Bradford County Flooding

I may not be able to attend the LMS meeting due to a doctor's appointment. The following addresses the items I wanted to address. I would suggest that a committee be created to address the flooding problems noted. My comments have not been reviewed by the Bradford Soil and Water Conservation District Supervisors so should be considered comments from a Bradford County resident.

Problem 3 Trail Ridge South Mine

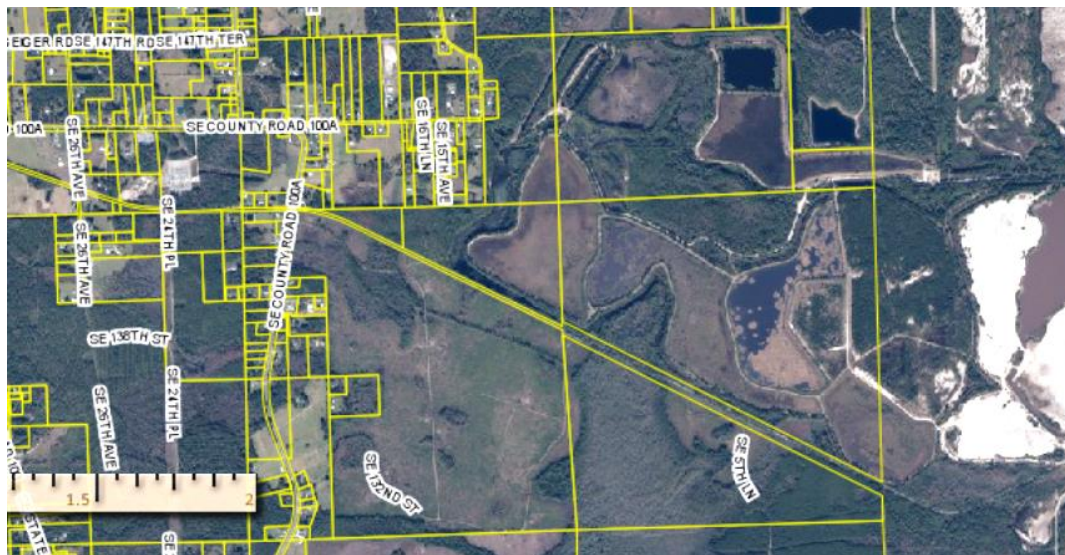
The Chemours Industrial Wastewater treatment system includes a series of raised settling ponds in Bradford County east of Starke shown in the image on the next page.

Failure of the structure along the western side of the ponds that holds the water in the ponds could create significant flood risk for homes just west of the holding ponds.

Water flow from the Chemours operations over the rail line (double yellow lines in the above image) onto the triangular shaped parcel south of the Chemours holding ponds owned by the North Florida Land Trust has been evaluated. During major rain events water flows over the railroad tracks flows west and then flows north back under the Bradford Apartment complex that was flooded during Irma. The discharges over the railroad tracts would not have been included in the reported Industrial Wastewater discharge reports.

Seek assurance from DEP that the Chemours holding pond system has sufficient capacity to hold stormwater and process water from a significant rain event.

Request DEP not allow the discharges over and under the rail road tracts south of the Chemours ponds.

Page 1 2022 Annual Report

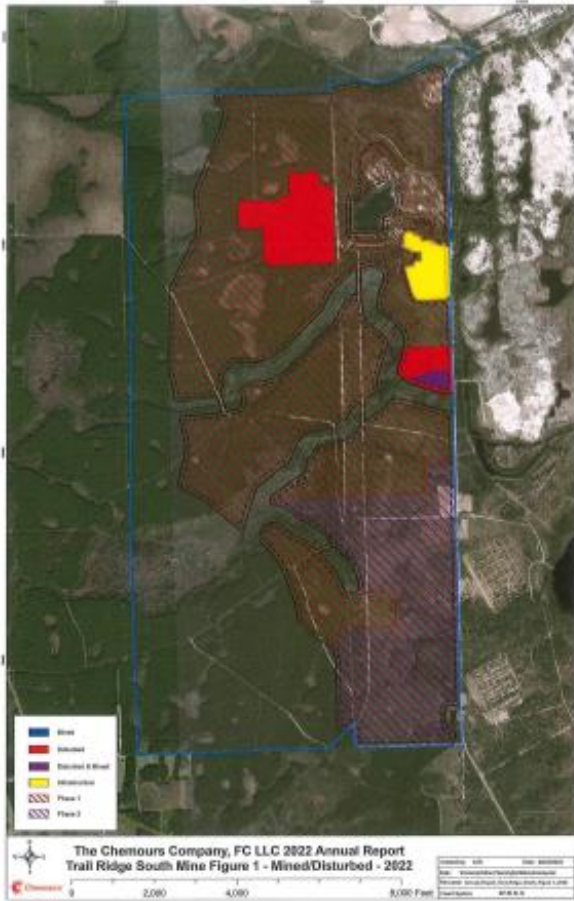
How deep was the pit?

What is the area of the pit?

What is the status of the stockpiled sand?

Did the pit receive water with radium levels of 9.3 piC/L noted in the radium exceedance documents?

What was/is the radium levels of the tailings?

Should the pre-dig pit area be shown as mined?

Should the pre-dig pit area in tan in the image on the right be shown as mined in the image on the left?

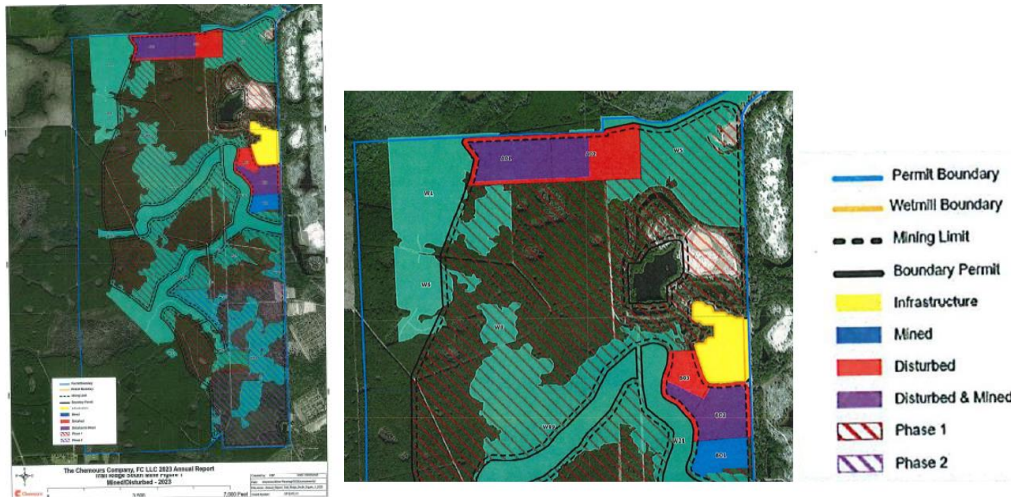
Where can the enclosures be found on OCULUS?

Firebreak
(January 31, 2024)

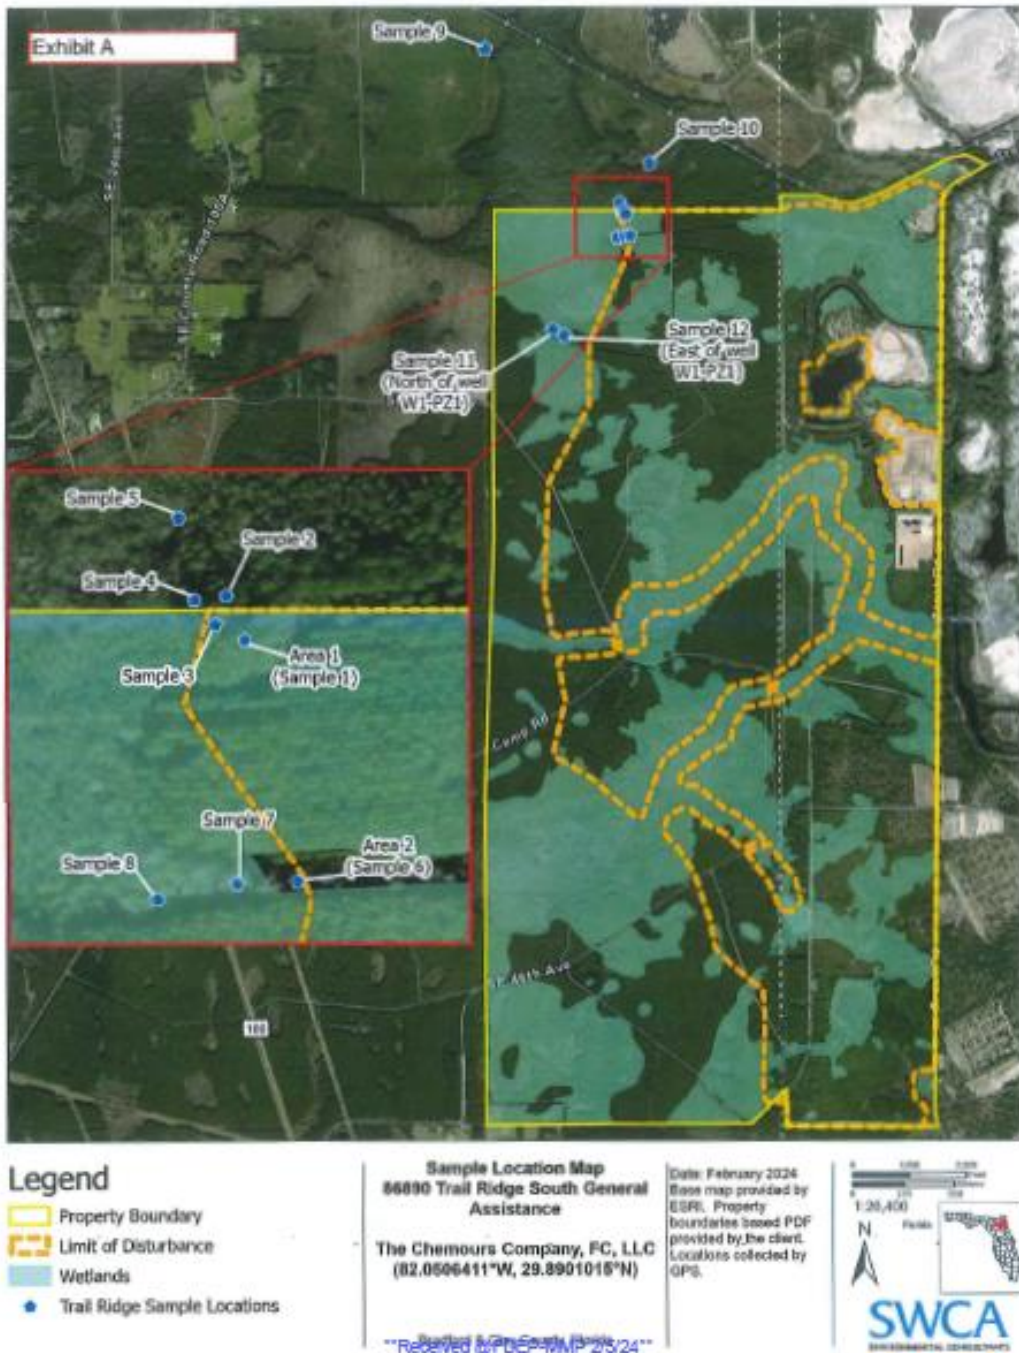
What data was used to establish that “there was no sediment deposition within the offsite wetlands”?

What is the grey material seen under the water in the above image?

Are Sample 2 and Sample 4 on NFLT property?

Why is the location of the berm breach not shown on the image?

Why is the location of the berm overtopping not shown on the image?

Where is the mine cell pit that was receiving the process pond water?
